**PZ&B Staff Combination Memorandum: Landmarks Preservation Commission and Town Council**

**SUBJECT:** HSB-24-0009 (ZON-25-0004) 335 COCOANUT ROW (COMBO)

**MEETING:** MARCH 19, 2025, LPC  
APRIL 9, 2025, TC

**Main Structure (Mediterranean Revival 1925)**

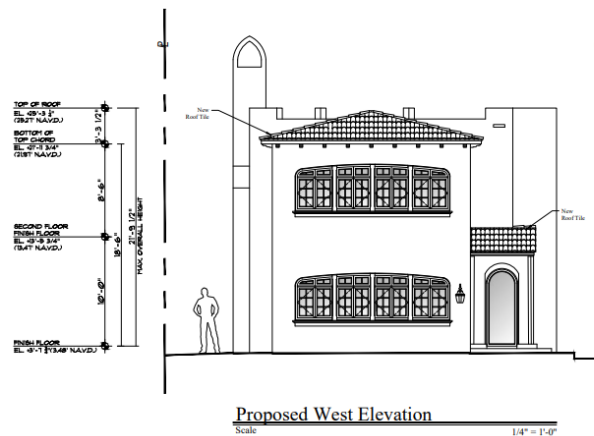
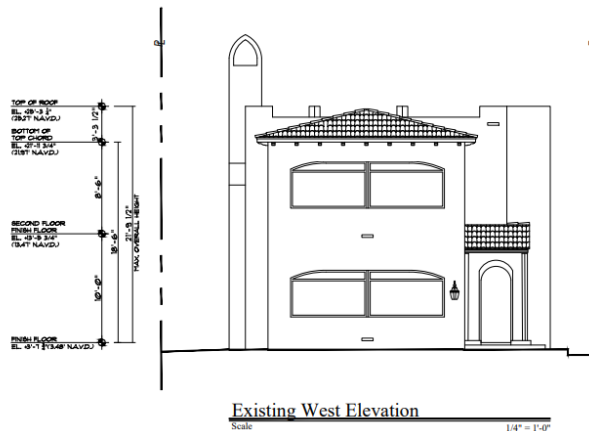
On the west (front) elevation, the existing barrel tiles will be replaced with new handmade barrel tiles. The screened in openings of the first-floor patio and second-floor terrace are proposed to be enclosed with four (4) pairs of casements windows and transoms with divided-light patterns. Additionally, the west entrance is proposed to be removed and fixed glass installed to enclose the existing entrance to the vestibule.

The screened in spaces and the entrance to the structure are character-defining features. The proposed changes remove and substantially alter these features. Less visual impactful interventions should be considered which still allow adaptive re-use of the property. **According to The Secretary of the Interior's Standards for Rehabilitation, "2. The historic character of a property shall be retained and preserved. The removal of historic materials or alteration of features and spaces that characterize a property shall be avoided."**

The best approach would be to retain and preserve the screened openings. However, given the applicant's desire to enclose these openings, staff recommends replicating the existing screen configuration with solid glazing. Directly south of the subject property, there is a sister apartment building (339 Cocoanut Row) originally named The Saint Rosaline which offers insight on how to

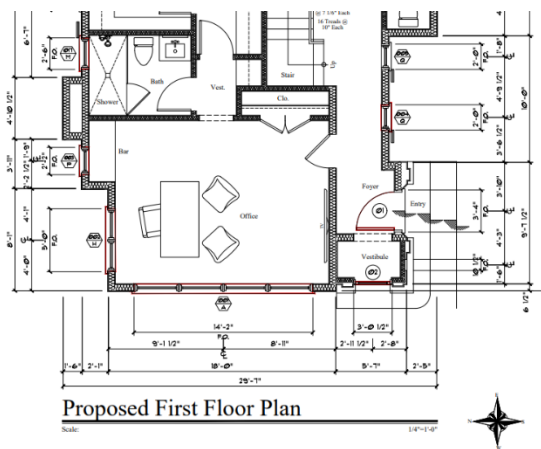
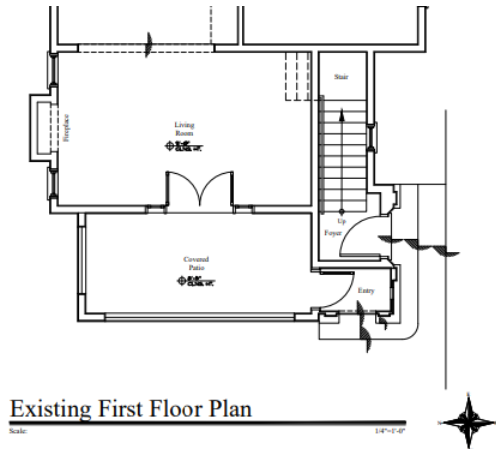
enclose these openings. The arched openings were enclosed with full-view glazing which retains the open feel of the space. The same approach can be adapted to the subject property, while ensuring that the window frames are minimally visible. The same treatment is recommended for the east and west screened openings of the patio and porch.

The two (2) main entrances to the structure, on the south and west elevations, are important to the history of the building as a two-unit apartment and should be retained.

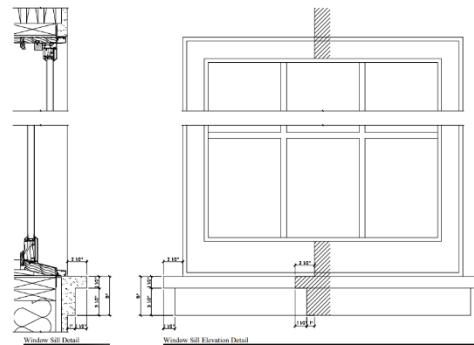
On the north and south elevations, the non-original windows will be replaced with 4/4 and 6/6 sash windows. Due to the varying window heights, the applicant could consider installing only vertically divided-light patterns to the top sashes of the windows. The plans show that several window and door opening locations will be altered. From a historic preservation perspective, original openings should be retained. Furthermore, the changes in opening sizes and locations disrupts the rhythm of solids to voids between the first and second floors.

The plans depict new sill details and wood shutters. Similar buildings from this time period, often did not have sill details. When present, these details had a much simpler design and profile than what is proposed.

#### Rear Structure (Masonry Vernacular 1949)

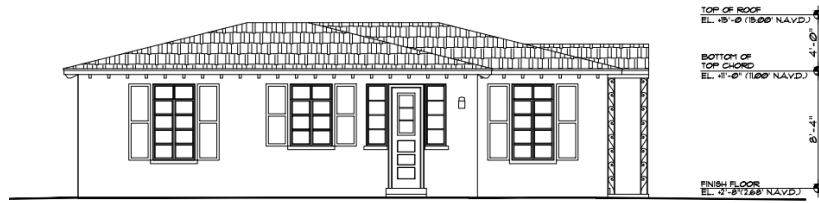
The existing asphalt shingles are proposed to be replaced with flat red clay tiles. Based on the original plans, the roof was designed with rigid asbestos shingles. The recommended replacement material is either dimensional asphalt shingles, flat white concrete tiles, or flat white clay tiles which were common roof material options for Masonry Vernacular structures of this period of construction. Therefore, staff can be supportive of the flat clay tiles if the color is revised to white.

**Existing North Elevation**

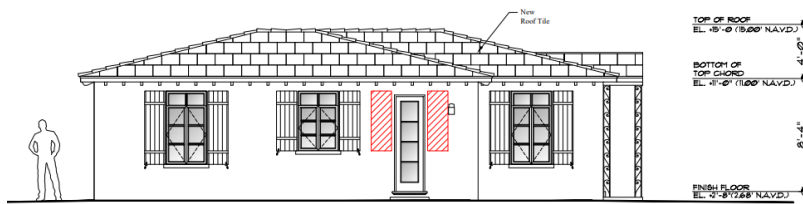
The existing pairs of casement windows with a transom are being replicated in kind. From a historic preservation perspective, removal of the windows that flank the door on the north elevation and the modification of a single door opening to a double door opening are changes not supported by staff. **According to The Secretary of the Interior's Standards for Rehabilitation, "5. Distinctive features, finishes, and construction techniques or examples of craftsmanship that characterize a historic property shall be preserved."**

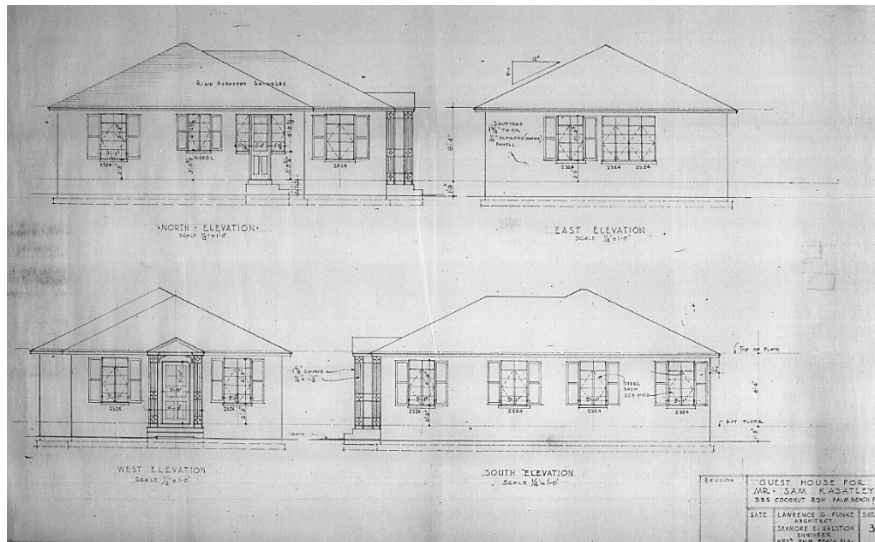
The same cypress wood shutters proposed for the main structure are proposed for the rear structure. Staff has concerns that the material choices seek to unify the architectural styles of both structures on the property. The architectural styles are reflective of their respective periods of construction and should be preserved and remain distinct.

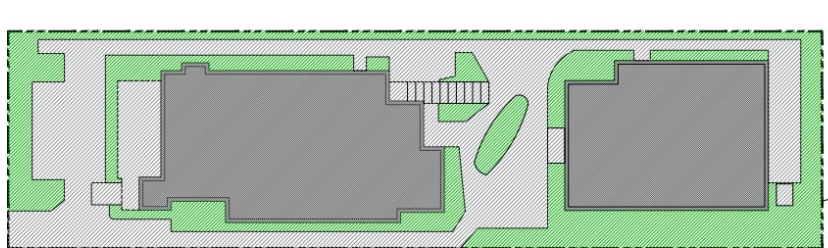
The front parking area will be reconfigured as a motor court with coral stone pavers and brick borders. A new pool is proposed between the structures. New a/c and pool equipment will be installed. **However, the plans must be revised to show how all new mechanical equipment will be screened with an enclosure or perimeter site plans as required by the Town's code.** New pedestrian gates and walkways are proposed for the property.

Proposed Landscape Open Space

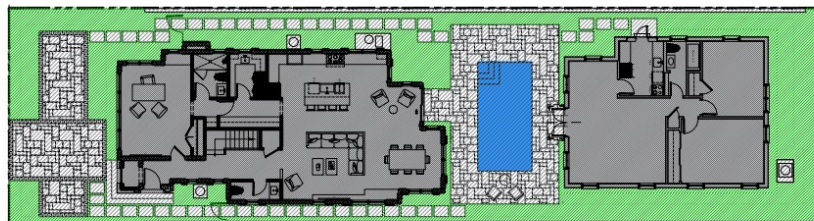
The proposed scope of work removes all of the existing hardscape on the property, excluding the footprint of the structures. As a result, compliance with current landscape open space requirements must be enforced. The applicant has submitted a variance to allow landscape open space to increase to 32.88% from the existing 27.77% but still does not meet the 45% minimum requirement, as outlined in the table below:

Since the footprints of the structures occupy 42.0% of the site or 2,520 SF, the site would only be able to accommodate 180 SF of hardscape for walkways, driveways, and other improvements to remain compliant.
